DATE: February 19, 2010
TO: Prospective Bidders
RE: Addendum #3 to the Bidding Document for
2009 Bond Program – Stadium Improvements
Lindale I.S.D.
Lindale, Texas

2009 BOND PROGRAM STADIUM IMPROVEMENTS	
LINDALE I.S.D. LINDALE, TEXAS	
PROJ: 2009-46	DATE: 02-19-2010
ADDENDUM No.	3
	SD-01

**Re: Lindale Football Stadium Improvements – L.I.S.D. (CTB #10-003)
ADDENDUM ITEMS - #CV-03**

**01** PARTIAL SITE PLAN
1" = 40'-0"

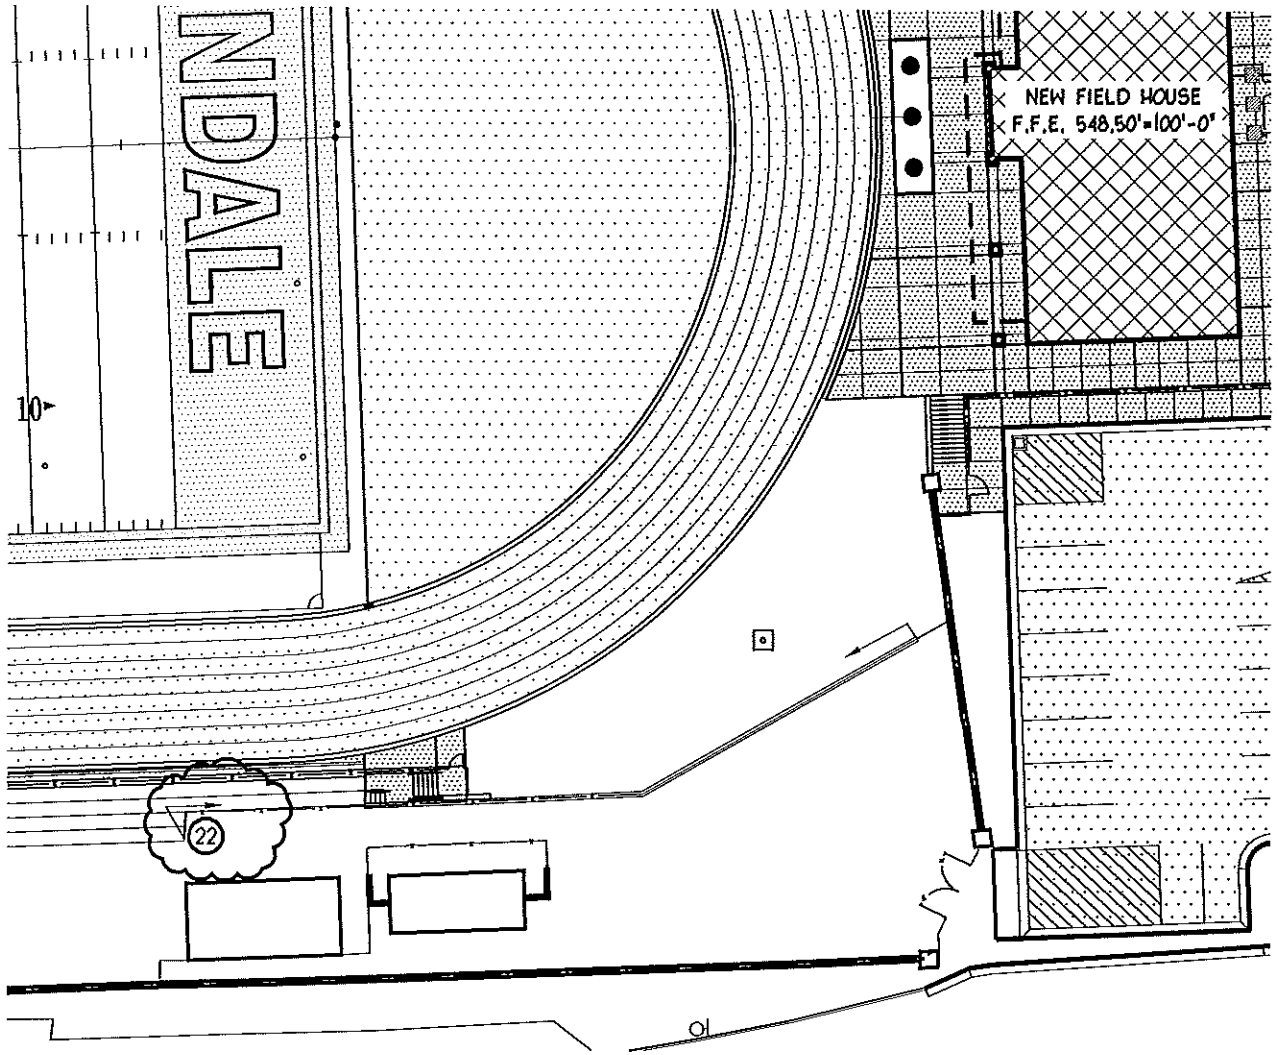
Sheet A1.0, Keyed Note #10 & Sheet A1.1, Keyed Note #22: See attached SD-01 for revised starting location of painted steel guardrail. Demolish existing chain link fencing in this location.
